PROJECT STATUS:		SHEET STATUS:		VILLAGE OF EKWOK, ALASKA		CORWIN & ASSOCIATES INC.		STATE OF ALASKA 49th		SHEET NUMBER	
1	JUNE 87	IHS NOTES, COMMUNITY NOTE & DELETION, HOME SHOWN ON LOT 7, BK. 6, ADDED TOTAL "SHEET No." CHANGE		SEWAGE IMPROVEMENT		Consulting Engineering		Professional Engineer		R-1	
NO. DATE		REVISION		DESIGNED: M.O., T.S.		- ANCHORAGE, ALASKA -		DATE: 1-18-85		SHEET NUMBER	
				DETAILED: B.S.				JOB NO. 8440		R-1	
				CHECKED: B.J.C.				APPROVED: B.J.C.		OF 4	
								SCALE: 1"=100'

**VILLAGE OF EKWOK, ALASKA**

**SEWAGE IMPROVEMENT**

DATE	REVISIONS	INITIALS
<b>U. S. Department of Health &amp; Human Services</b> <b>Public Health Service</b> <b>Indian Health Service</b>		
<b>EKWOK, ALASKA</b>		SHEET NO. R-4
LAGOON DETAILS, SEPTIC TANK INSTALLATION & ARCTIC HOUSE SEWER WALL CONNECTION PUBLIC LAW 86-121 PROJECT PROJECT NO. AN-87 368		
DRAWN BY: LOWDERMILK DATE: 7-87		CHECKED BY: _____ DATE: _____
<b>SANITATION FACILITIES CONSTRUCTION BRANCH</b> <b>ENVIRONMENTAL HEALTH BRANCH</b> ALASKA AREA NATIVE HEALTH SERVICE ANCHORAGE, ALASKA		
TOTAL SHEETS 4

SITE PLAN SCALE 1"=100'

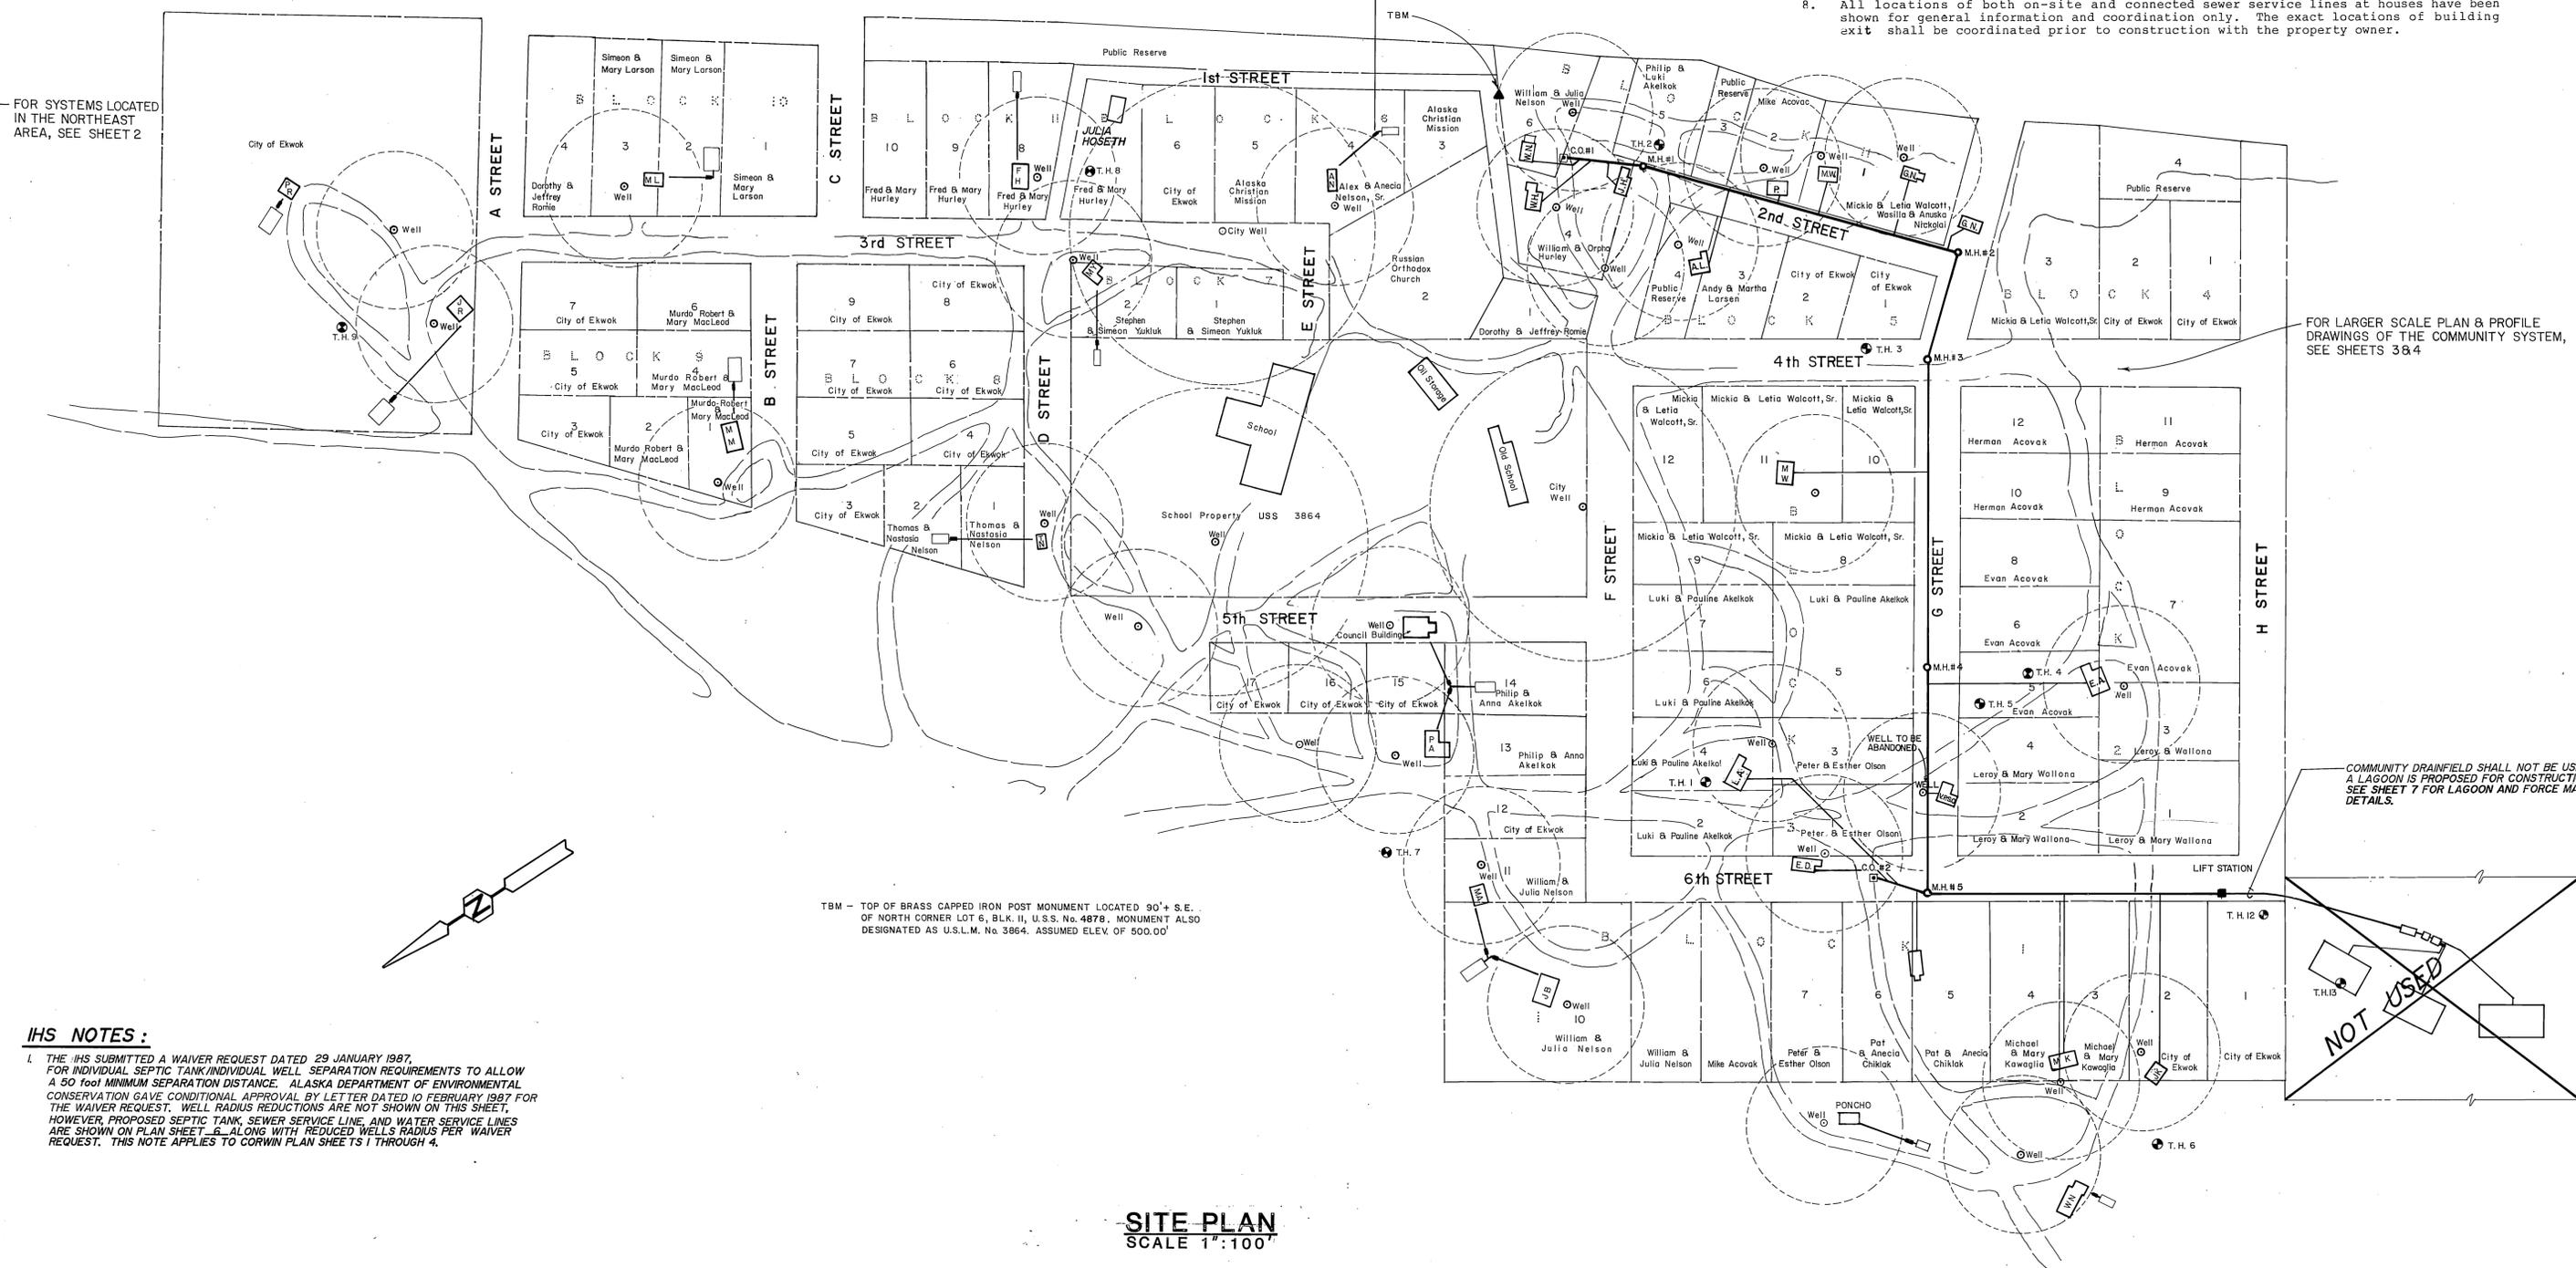
1. THE IHS SUBMITTED A WAIVER REQUEST DATED 29 JANUARY 1987 FOR INDIVIDUAL SEPTIC TANK/INDIVIDUAL WELL SEPARATION REQUIREMENTS TO ALLOW A 50 FOOT MINIMUM SEPARATION DISTANCE. ALASKA DEPARTMENT OF ENVIRONMENTAL CONSERVATION GAVE CONDITIONAL APPROVAL BY LETTER DATED 10 FEBRUARY 1987 FOR THE WAIVER REQUEST. WELL RADIUS REDUCTIONS ARE NOT SHOWN ON THIS SHEET, HOWEVER, PROPOSED SEPTIC TANK, SEWER SERVICE LINE, AND WATER SERVICE LINES ARE SHOWN ON PLAN SHEET 6 ALONG WITH REDUCED WELLS RADIUS PER WAIVER REQUEST. THIS NOTE APPLIES TO CORWIN PLAN SHEETS 1 THROUGH 6.

**LAGOON SITE PLAN**  
SCALE: 1" = 50.0'

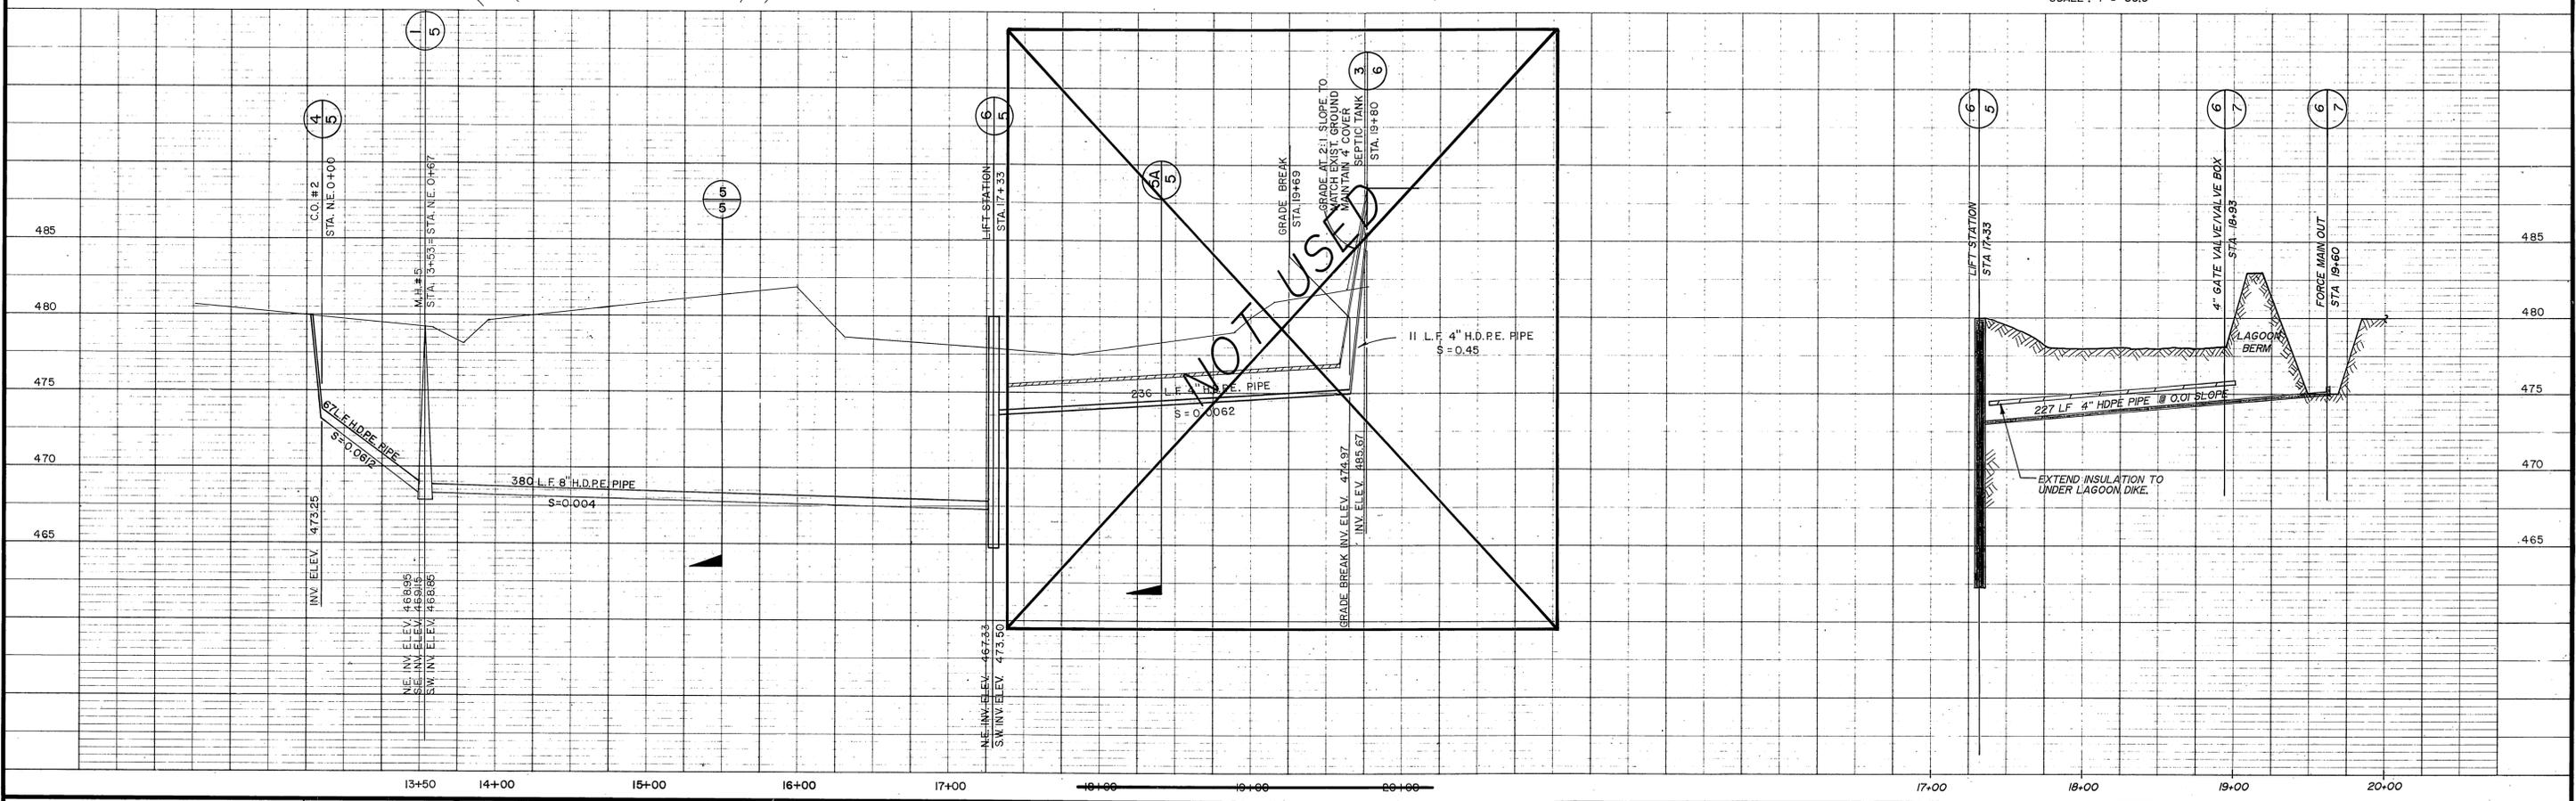
PROJECT STATUS:		SHEET STATUS:	
1	JUNE 87	NORTH ARROW MOVED, COMMUNITY DRAINFIELD DELETED, RD/pml	
		PROPOSED LAGOON SHOWN, FORCE MAIN PROFILE REDRAWN, SHEET No. CHANGED.	
NO.	DATE	REVISION	BY CHK

**6 Lift Station Section**

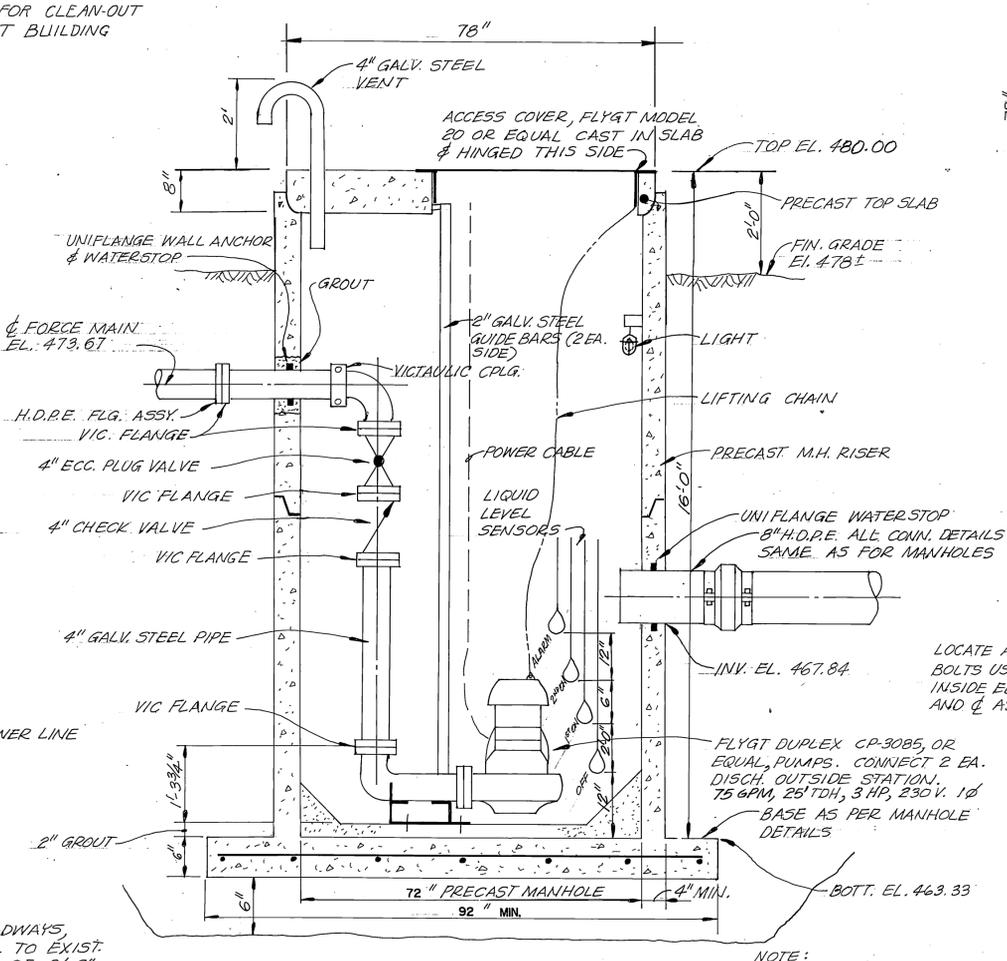
PROJECT STATUS:		SHEET STATUS:	
1	JUNE 87	LIFT STATION WET WELL, DIAMETER CHANGE, PRECAST TOP CHANGES, "SHEET No." CHANGES, IHS NOTE ADDED.	RD/jpm
NO.	DATE	REVISION	BY

**IHS NOTES:**  
INSTALL LIFT STATION CONTROL PANEL IN PAD-MOUNTED POWER GLASS ENCLOSED ENCLOSURE MODEL 54-2 AS MANUFACTURED BY WESTERN POWER PRODUCTS, INC. (OR APPROVED EQUAL). CONCRETE FOUNDATION PAD SHALL BE CONSTRUCTED PER MANUFACTURER'S RECOMMENDATIONS. SEE SHEET 6 FOR LOCATION.
